# SERVICE TIPS

GAME: "QIX"

SUBJECT: GAME POWERS UP BUT WILL NOT COIN UP. BATTERY IS TOO LOW.

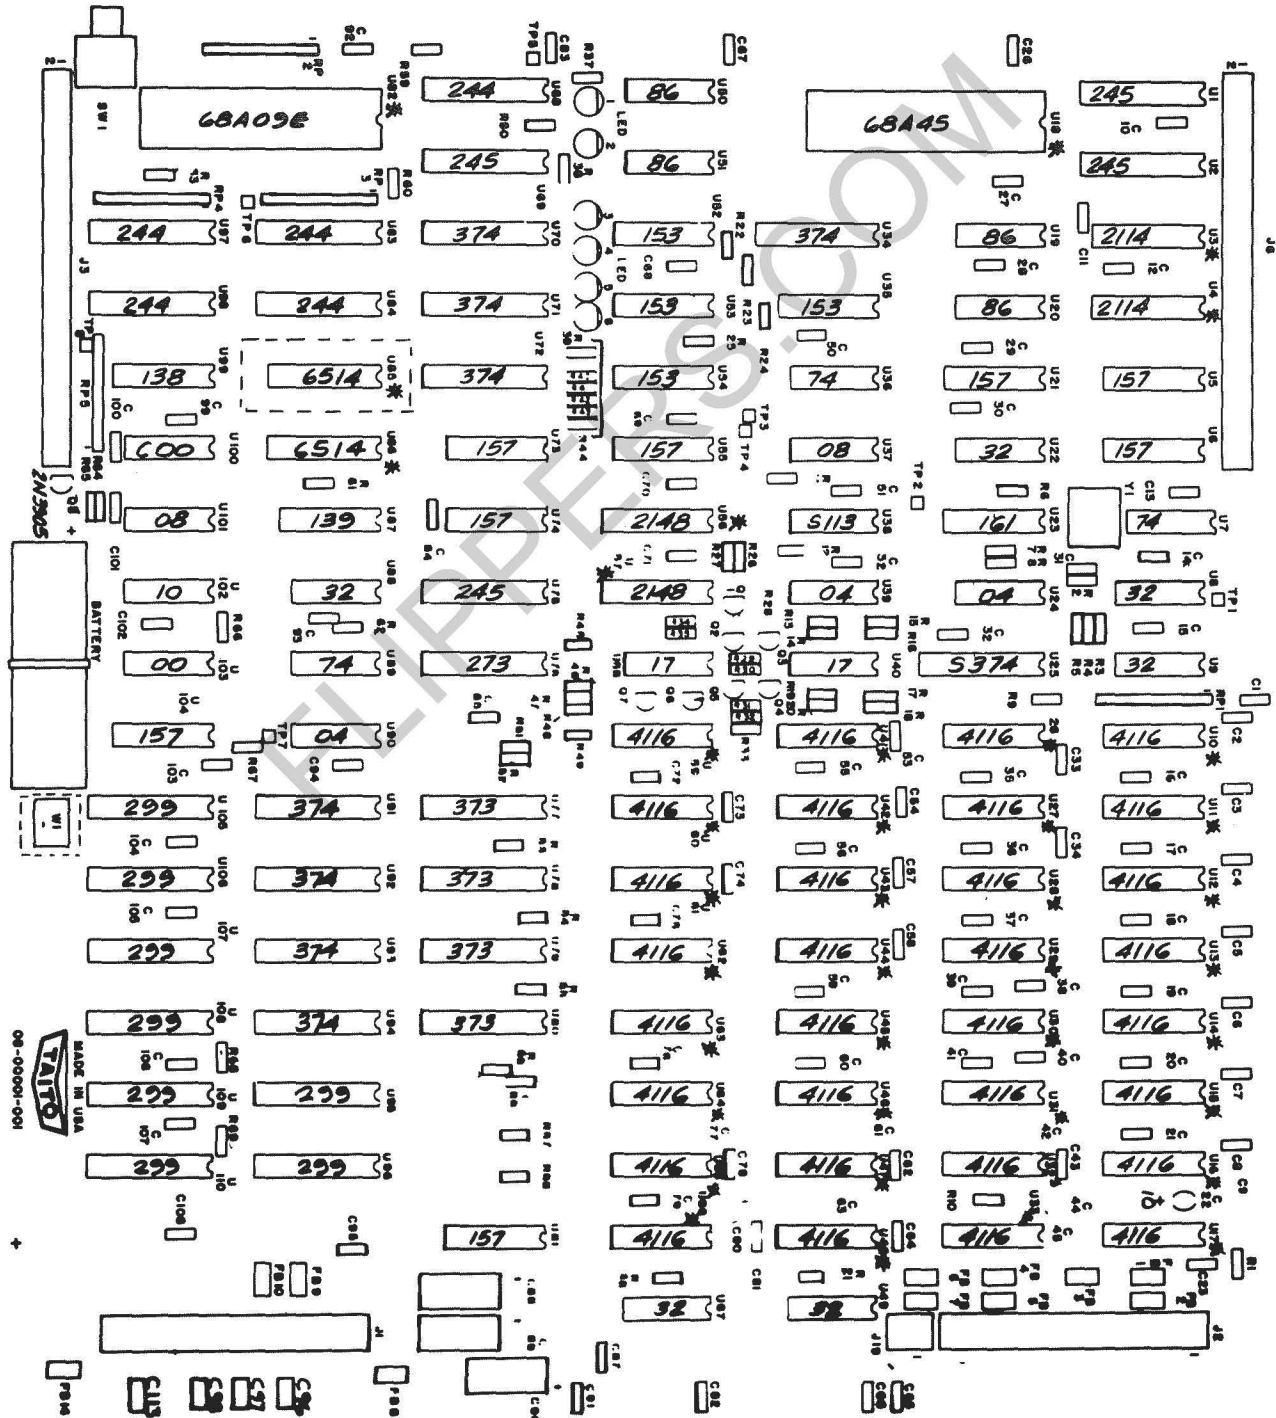
PROCEDURE: OPEN BACK DOOR, PULL W1 OUT ON VIDEO BOARD (BLUE JUMPER SEE FIGURE 1). WAIT 2 MINUTES, POWER BACK ON AND INSERT W1 BACK IN. IF LANGUAGE SELECT FRAME DOES NOT COME ON CRT, POWER DOWN, REMOVE W1 AGAIN, SHORT PINS 18 AND 9 ON U85 (SEE FIGURE 1) POWER BACK ON AND INSERT W1 BACK IN.

SOLUTION: RESET CMOS RAM. IT SHOULD BE NOTED THAT ALL AUDIT TOTALS WILL  
BE WIPED OUT.

LEAVE GAME ON FOR 12 HOURS. IF THIS PROCEDURE DOES NOT WORK WHEN YOU TURN IT BACK ON, REPLACE BATTERY.

FIGURE 1

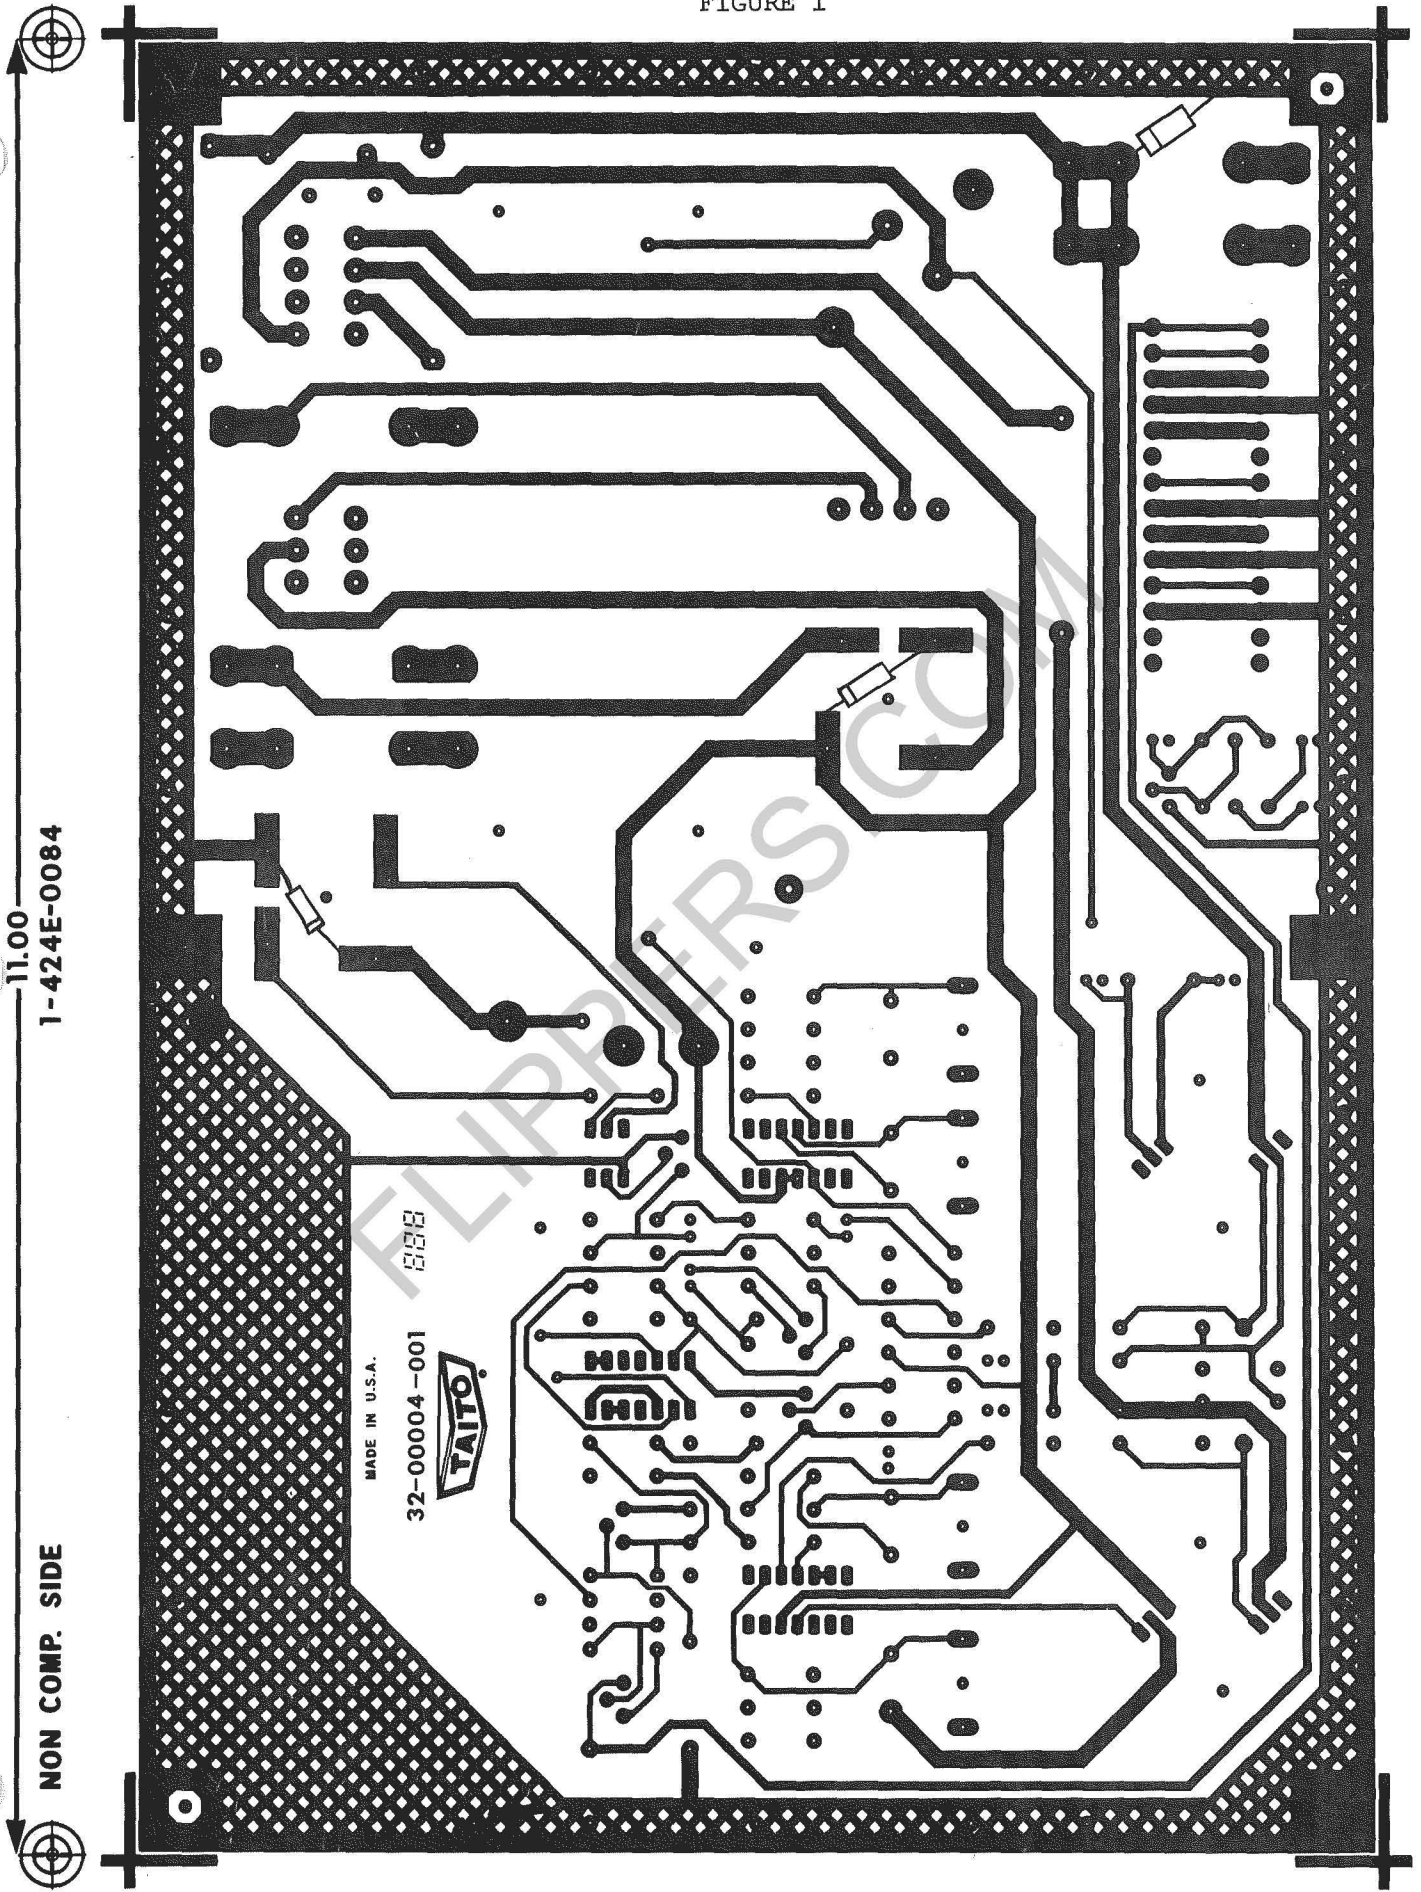
SUBJECT: NOISY A.C. LINE CAUSING GAME TO FREEZE UP.

SOLUTION: ADD THREE DIODES TO CATCH TRANSIENTS IN A.C. LINE.

ON THE TOP MIDDLE OF THE BOARD YOU WILL SEE THE LEGS OF BR1. SOLDER CATHODE OF THE IN6276 TO THE OFFSET LEG OF THE BRIDGE. SOLDER THE ANODE OF THE DIODE TO THE LEG THAT IS AT THE DIAGONAL OF THE OFFSET LEG. (REFER TO FIGURE 1).

IN THE MIDDLE OF THE BOARD YOU WILL SEE THE LEGS OF BR2. SOLDER THE CATHODE (WHITE MARK) OF THE IN6281 TO THE OFFSET LEG OF THE BRIDGE RECTIFIER. SOLDER THE ANODE TO THE LEG THAT IS KITTY CORNER OF THE OFFSET LEG. (REFER TO FIGURE 1).

IN THE LOWER RIGHT OF THE BOARD, YOU WILL SEE THE LEG OF THE FUSE HOLDER, F4 AND F5 (SEE FIGURE 1). SOLDER THE CATHODE (WHITE MARKS) OF THE IN6267 TO ONE OF THE FOUR LEGS THAT ETCHES BETWEEN THEM. SOLDER THE ANODE TO THE GROUND ETCH THAT RUNS ALL AROUND THE BOARD.

FIGURE 1

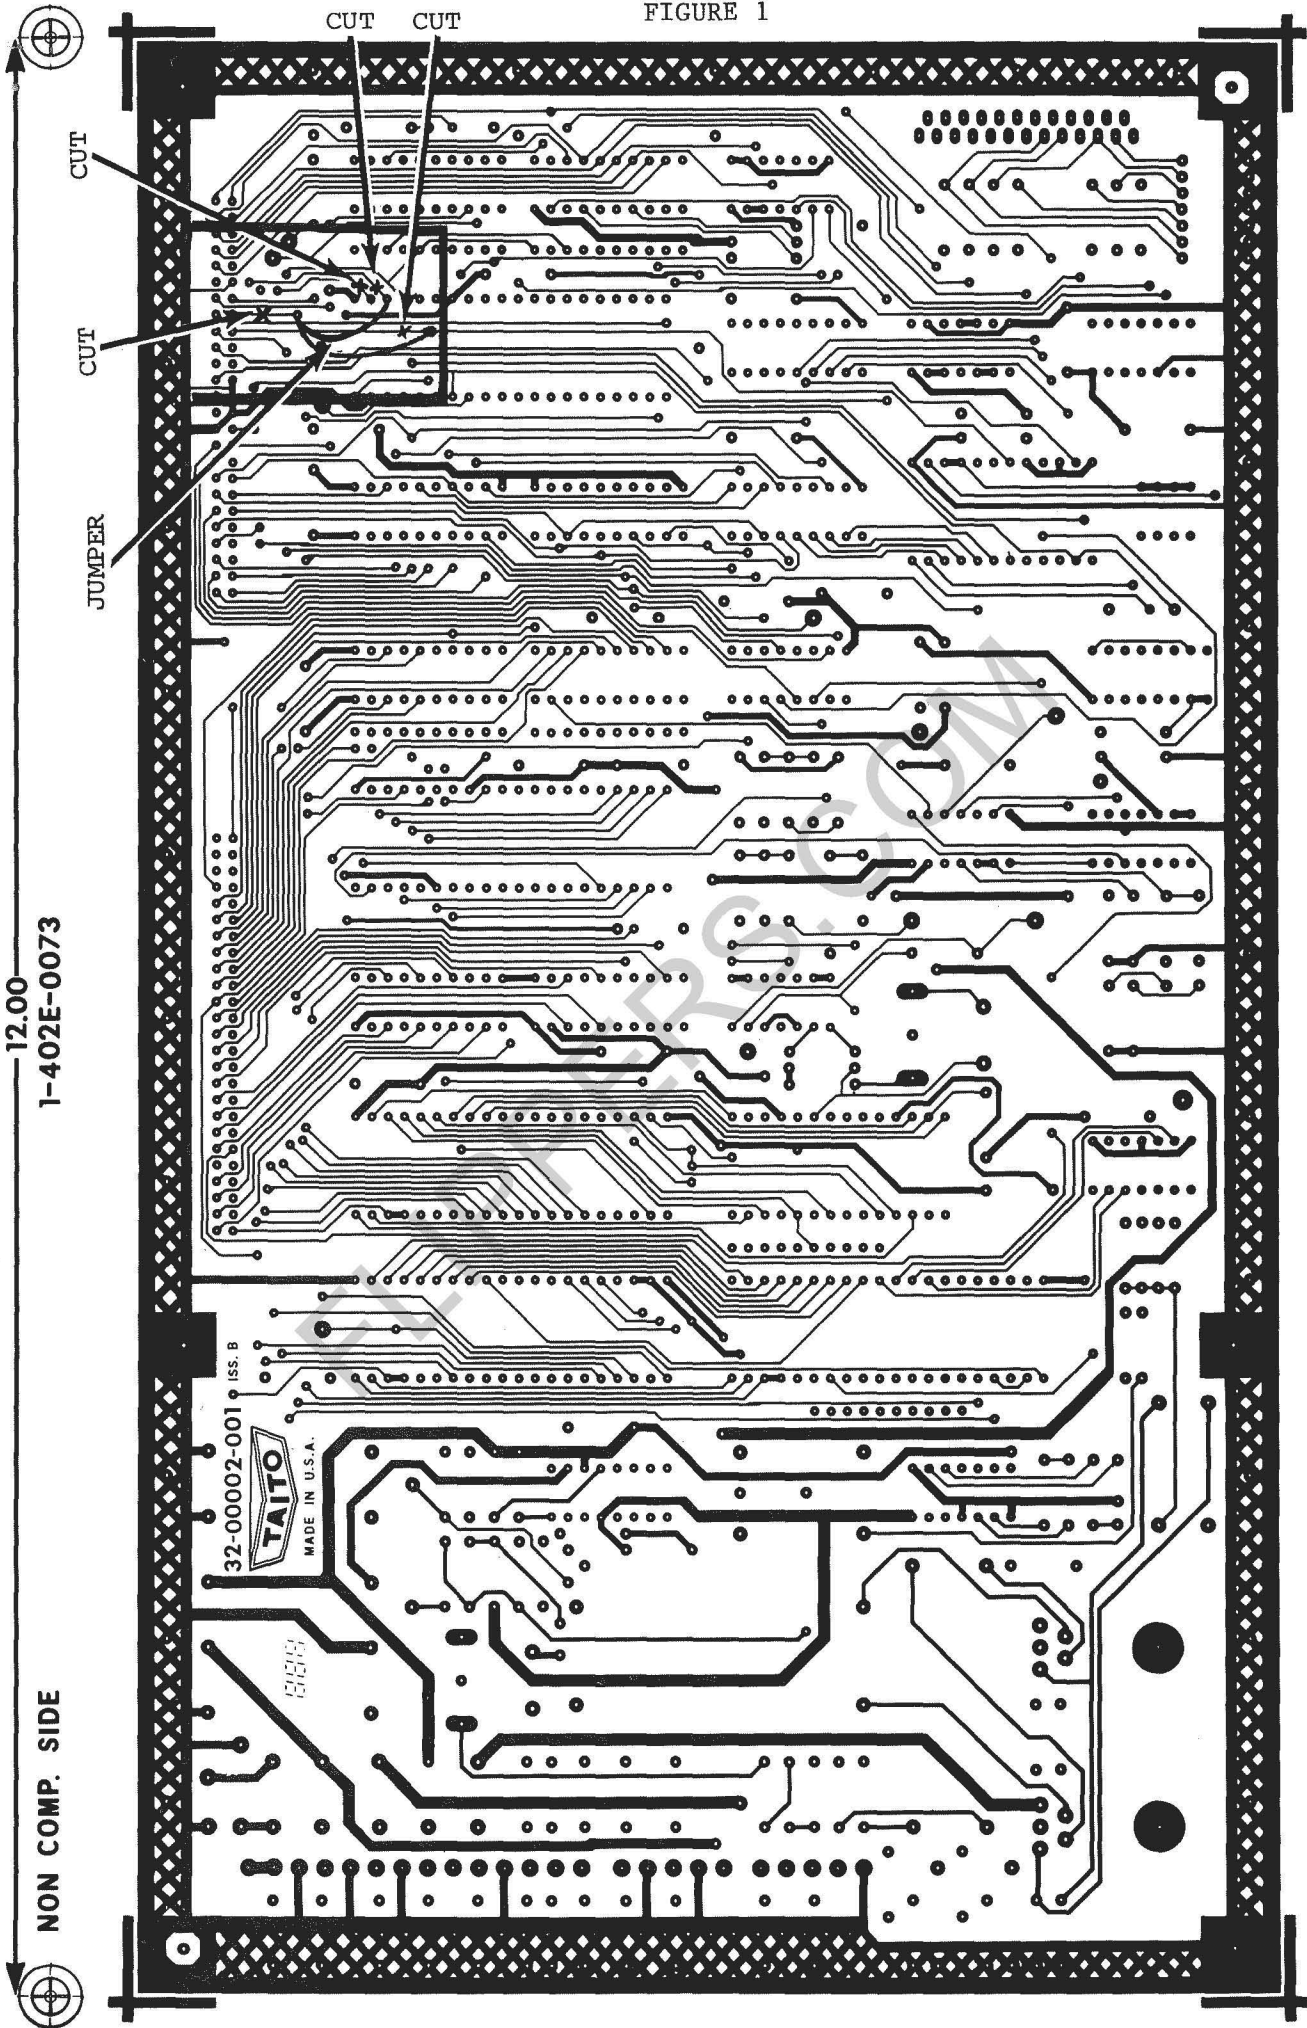
**SUBJECT:** INTERMITTENT LOCK UP, DATA/SOUND BOARD (REVISED 81-19)

**SOLUTION:** CUT NMI AND JUMPER DINT 1 AND DINT 2 TOGETHER ON DATA BOARD

**PROCEDURE:** ON THE ETCH SIDE OF THE DATA/SOUND BOARD, CUT FOUR TRACES. (SEE FIGURE 1). TRACE FROM U2 PIN 2, U2 PIN 3, THE TRACE J6 PIN 16 TO THE FEED THROUGH, AND CUT THE TRACE BETWEEN J6 PIN 18 AND U22 PIN 7. ADD A JUMPER WIRE FROM U2 PIN 3 TO THE FEED THROUGH HOLE THAT WAS CONNECTED TO J6 PIN 16. ADD A JUMPER FROM U2 PIN 3 AND U22 PIN 7 (ON THE ETCH SIDE OF THE BOARD. PLEASE, SINCE U22 IS IN A SOCKET).

FIGURE 1

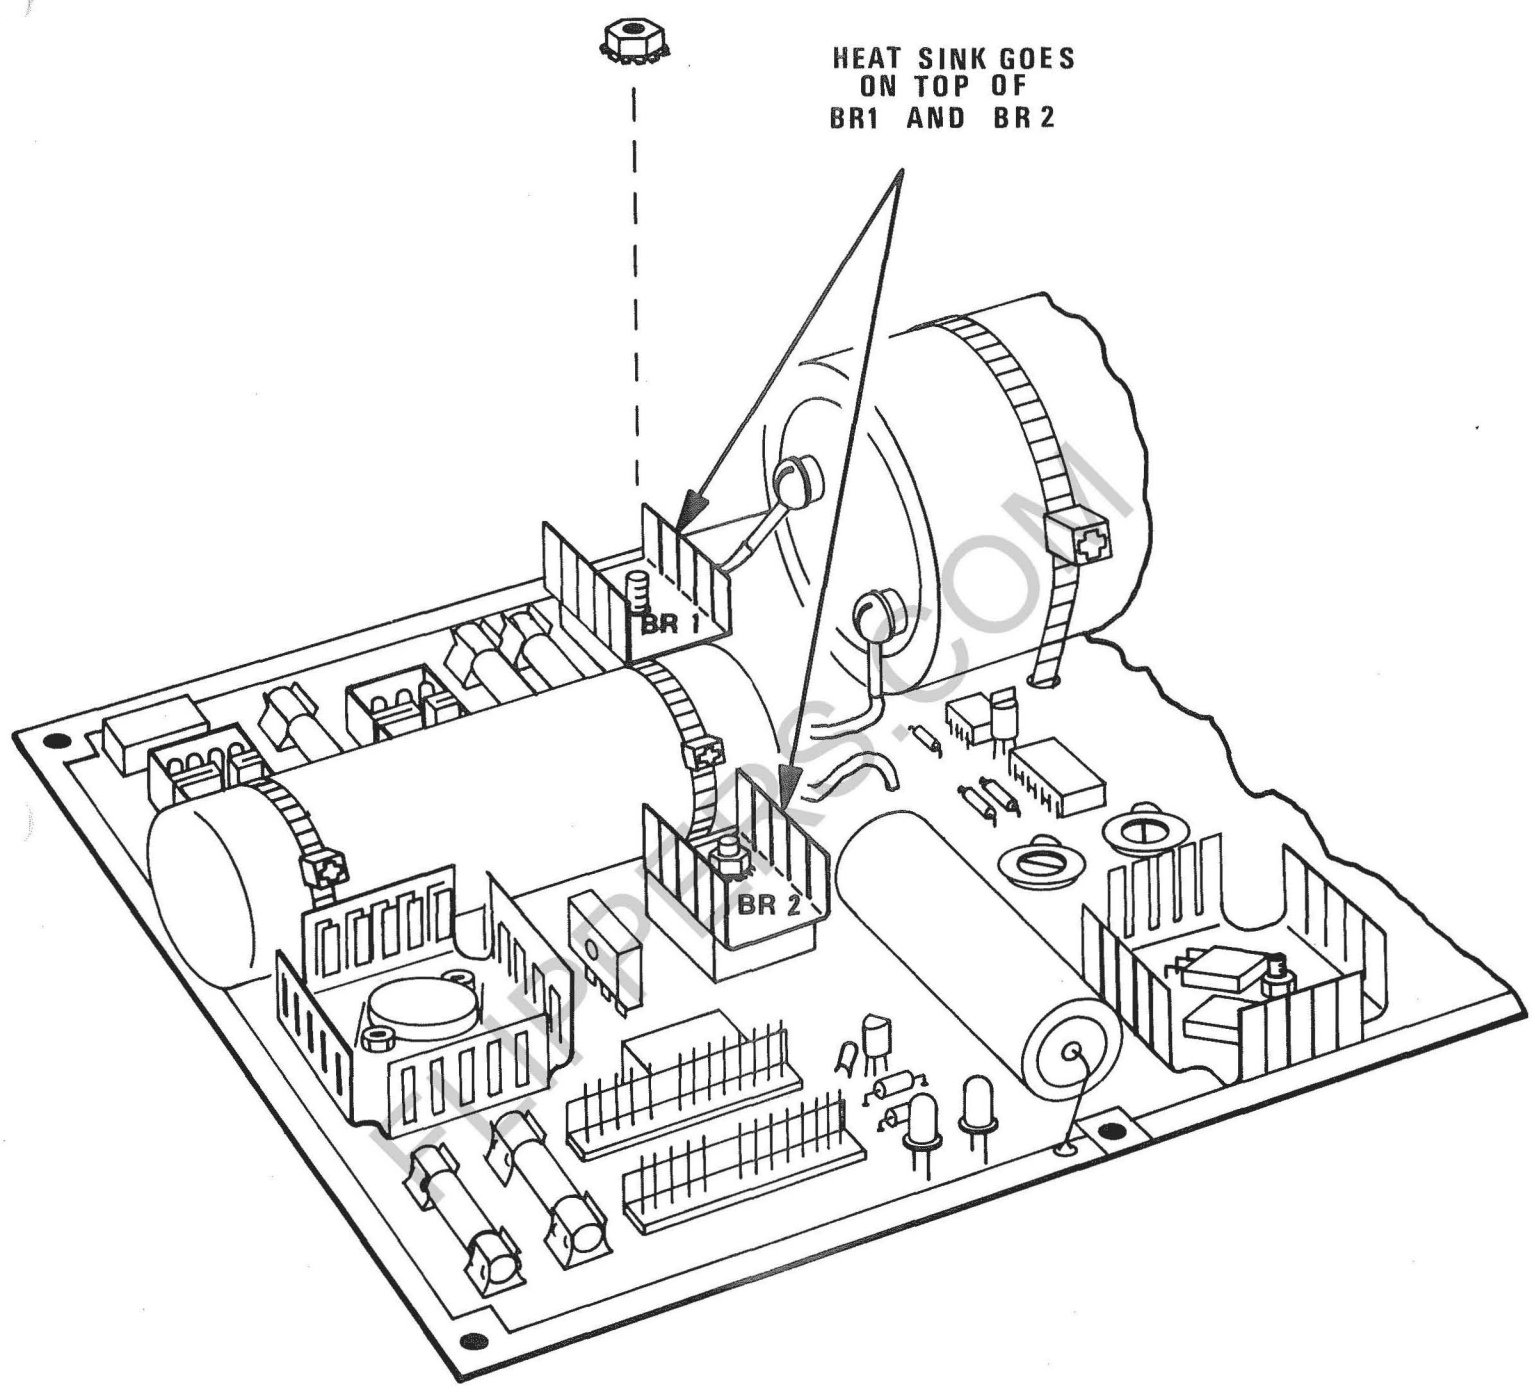
SUBJECT: BR1 AND BR2 HEATING UP TO THE EXTENT OF BREAKING DOWN INTERNALLY.

SOLUTION: ADDING HEAT SINKS ONTO BR1 AND BR2.

PROCEDURE: POWER DOWN GAME, REMOVE POWER SUPPLY P.C.B. 08-00007-001  
APPLY HEAT SINK COMPOUND TO THE TOP OF BR1 AND BR2 (REFER  
TO FIGURE 1). PLACE A HEAT SINK ON TOP OF BR1 ALIGNING HOLES  
AND MAKING SURE THAT HEAT SINK DOESN'T TOUCH ANY OTHER  
COMPONENTS. FEED THE SCREW THROUGH THE ETCH SIDE OF THE  
POWER SUPPLY. TIGHTEN THE NUT SNUGGLY. REPEAT PROCEDURE  
FOR BR2.

HEAT SINK GOES  
ON TOP OF  
BR1 AND BR 2
